# 18 WELL ROAD

AMENDED PROPOSED SINGLE STOREY REAR EXTENSION AND LINK

**DESIGN & ACCESS STATEMENT | ADDENDUM**

JUNE 2018

FIGURE4. BASEMENT CONNECTION LINK OPTION 01

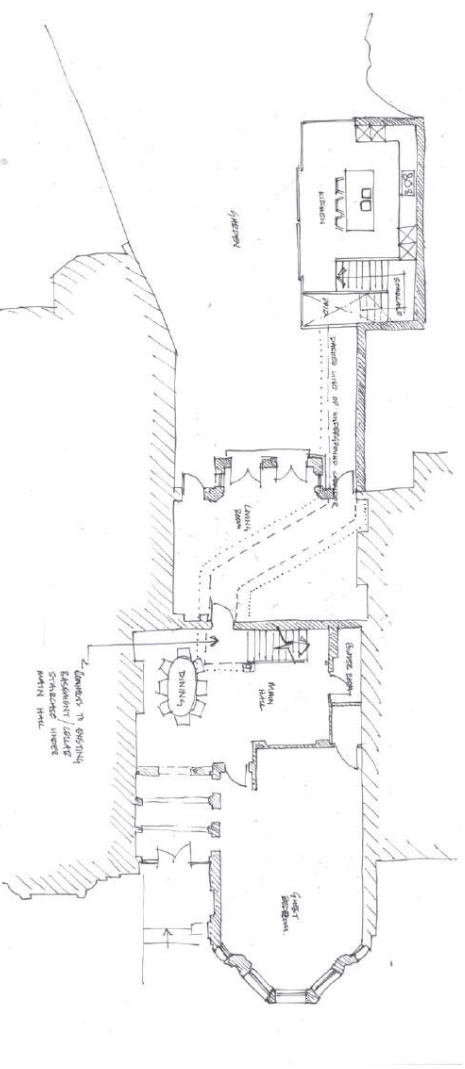
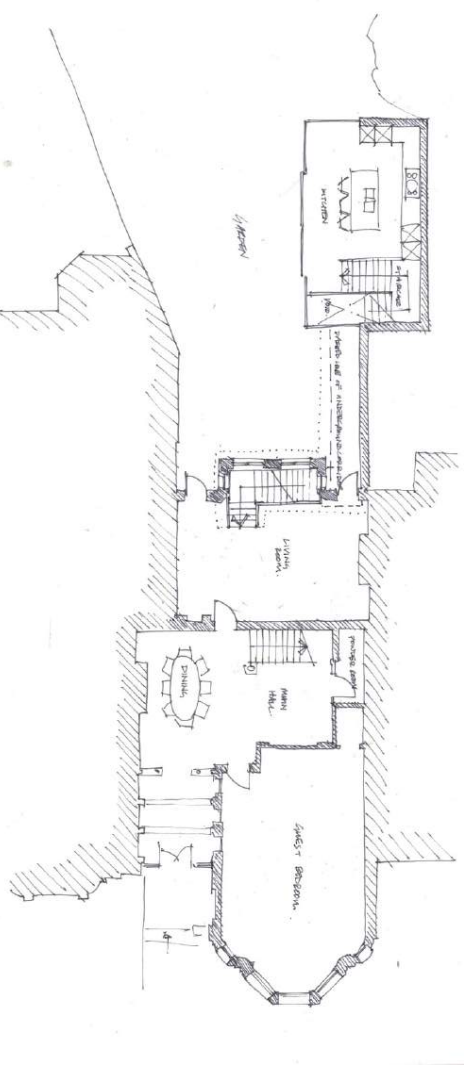
2.2.1 The design team presented sketches to illustrate exploration of options to create a subterranean connection between the existing house and the proposed garden 'pavilion' extension. The principles of such a design were discussed, and it was agreed that this would not be a viable solution in view of the complexities outlined below:

- Constraints of restricted access to the 'landlocked' rear garden.
- Technical difficulties and risks associated with temporary support of the existing historic rear elevation of the house to create subterranean space.
- Impact to the internal layout of the existing house to incorporate a staircase leading to a subterranean link.
- Impact on adjoining properties.

2.2.2 It was concluded due to the foregoing issues that a subterranean connection between the main house and proposed garden 'pavilion' extension would not represent a viable option to overcome the Council's concerns, and would in fact result in greater impact and harm to the historic fabric of the property.

FIGURE6. LINK SECTION & REAR ELEVATION AMENDED PROPOSED LINK

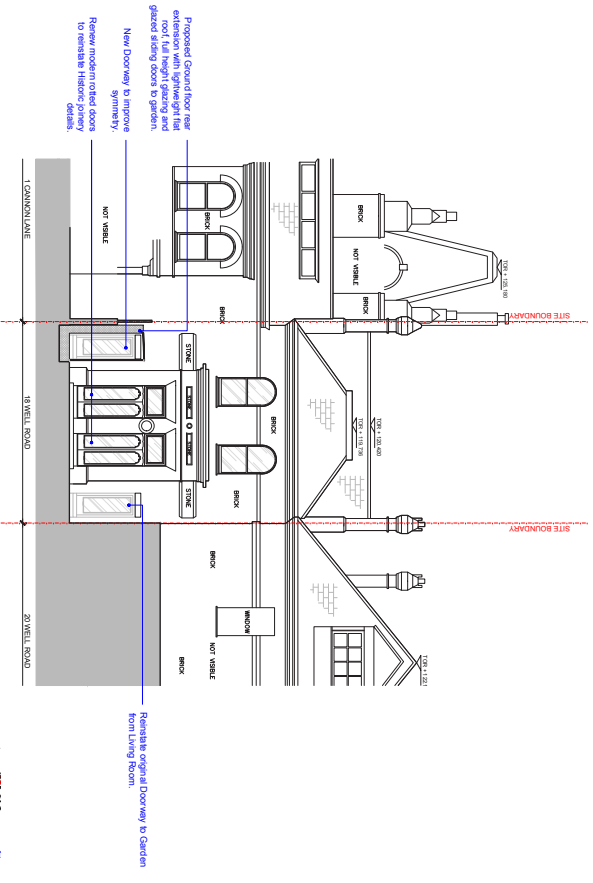
- 3.1.1 The proposed amendment to the glazed link reduces its height in relation to the garden 'pavilion' extension, to create a lower roof to this element of the scheme, resulting in a more subservient structure which is expressed as a transitional space between the main house and proposed kitchen area, rather than as part of the larger and taller structure.

- 3.1.2 The reduced height link element is now consistent with the transom between the adjacent French doors and fanlight windows to the rear elevation of the main house.

- 3.1.3 The width of the link element remains as narrow as possible while encompassing the proposed new single door opening in the rear elevation of the main house. The roof profile of the link has been amended to fall away from its glazed elevation, to eliminate any need for a projecting overhang.

FIGURE8. SOUTH ELEVATION AMENDED PROPOSED EXTENSION AND LINK

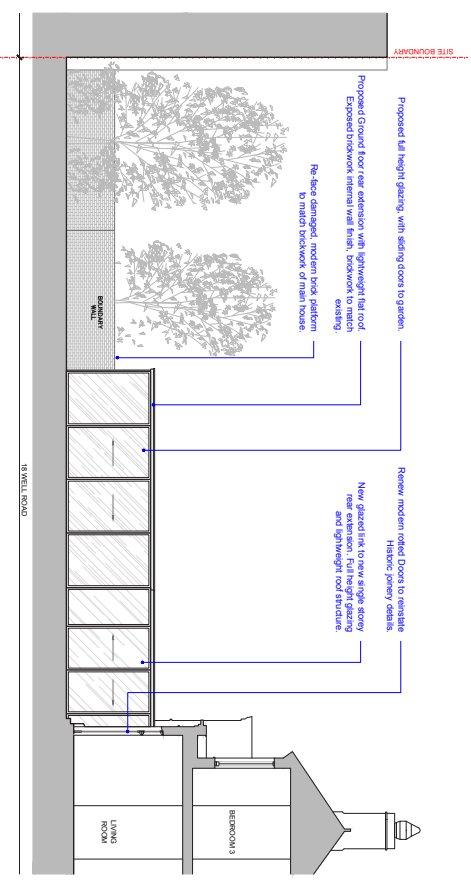
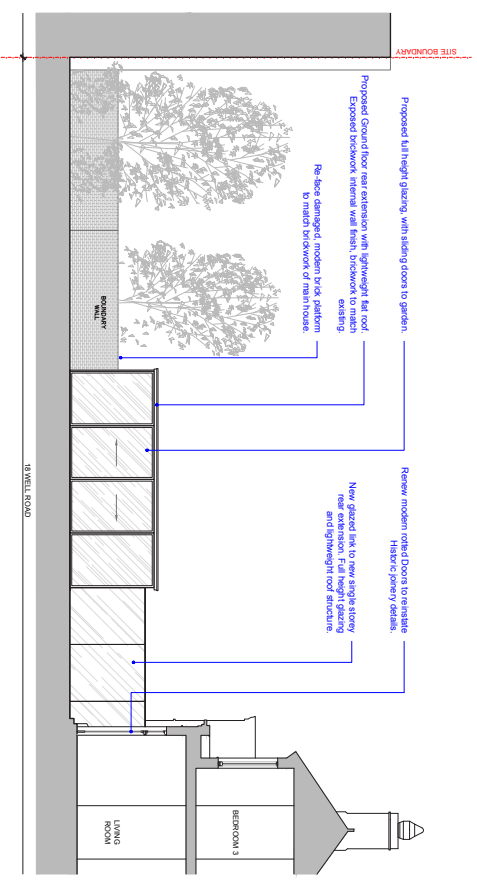
- 3.2.1 The proposed amendment to the glazed link element results in a lower and more subservient structure in relation to the main house and garden 'pavilion' extension.

- 3.2.2 The proposal to reduce the visual prominence of the link is reinforced through a change of strategy for its composition and structure. Where previously expressed as large format sliding glazed doors and panels with aluminium frames, consistent with the approach for the garden 'pavilion' extension, the link has been reconsidered as a truly frameless 'glass box', comprising large sheets of silicone bonded structural glazing to the wall and roof. This allows the link to be expressed as a distinctly separate and visually subservient element simply connecting the main house to the kitchen extension.

- 3.2.3 The omission of any framing from the link glazing, and incorporation of a glass roof in lieu of the originally proposed solid roof reinforces the transparent nature of this element, retaining a visual connection between the garden and the rear elevation of the main house.

FIGURE | 5. AMENDED PROPOSED LANDSCAPE SCHEME

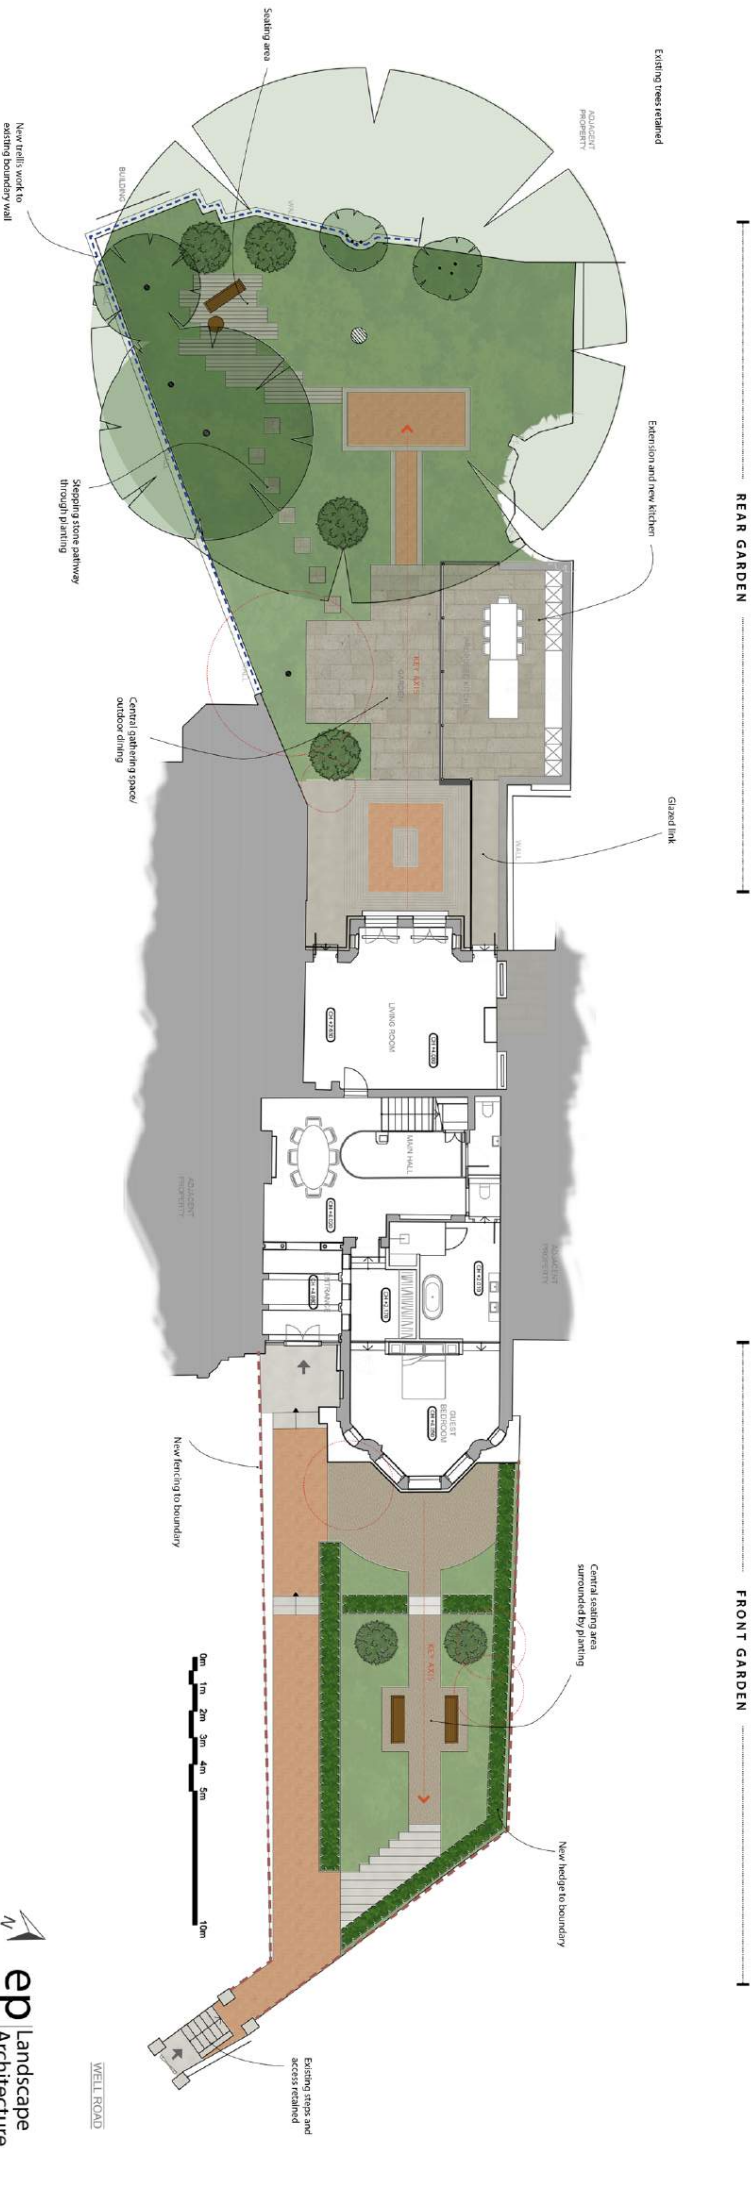
- 3.1.4 Pergola:  
In response to Officers' comments, the originally proposed pergola structure has been omitted from the scheme, as this was not considered to create a sense of symmetry to the rear elevation. Refer to amended landscape scheme (Figure 15).

FIGURE 16. VISUAL FROM GARDEN LOOKING BACK TO THE PROPERTY AND THE PROPOSED EXTENSION AND LANDSCAPE | DUSK LIGHT

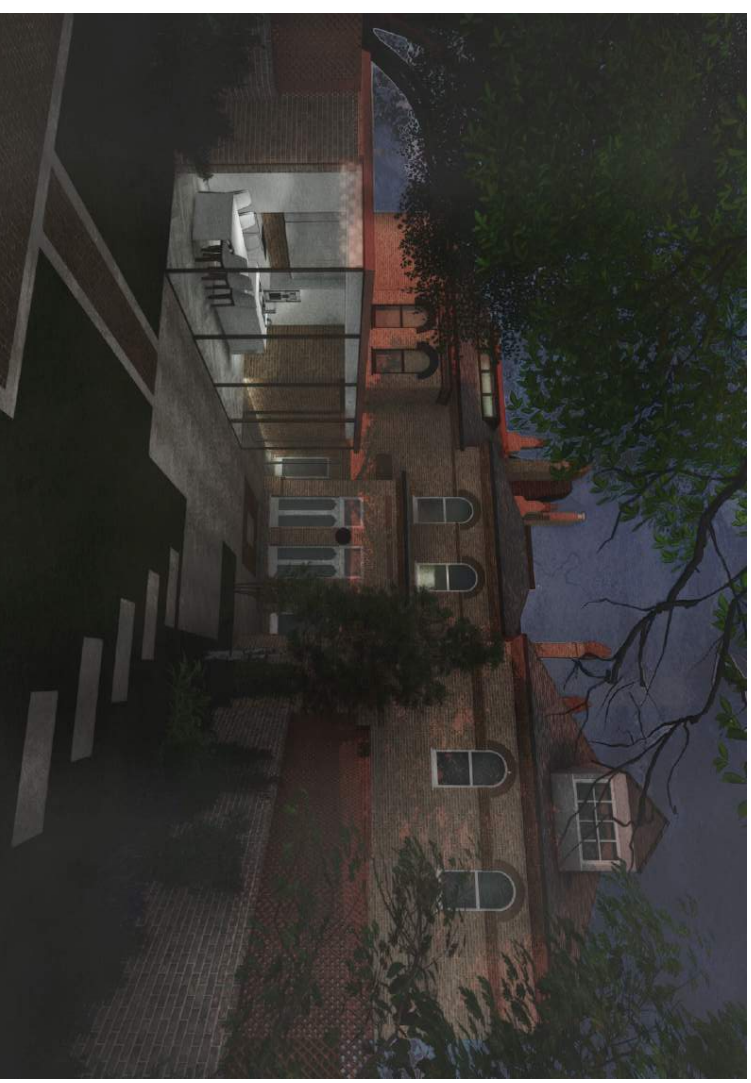
- 4.1.1 The amended proposals create a more visually subservient glazed link structure, which is expressed as a distinctly separate transitional space between the main house and proposed kitchen extension. The lightweight, transparent nature of the link, allows the visual symmetry of the rear elevation of the main house to be expressed, and is seamlessly integrated into the garden area through careful selection of materials to bring the external surfaces through to the internal space.
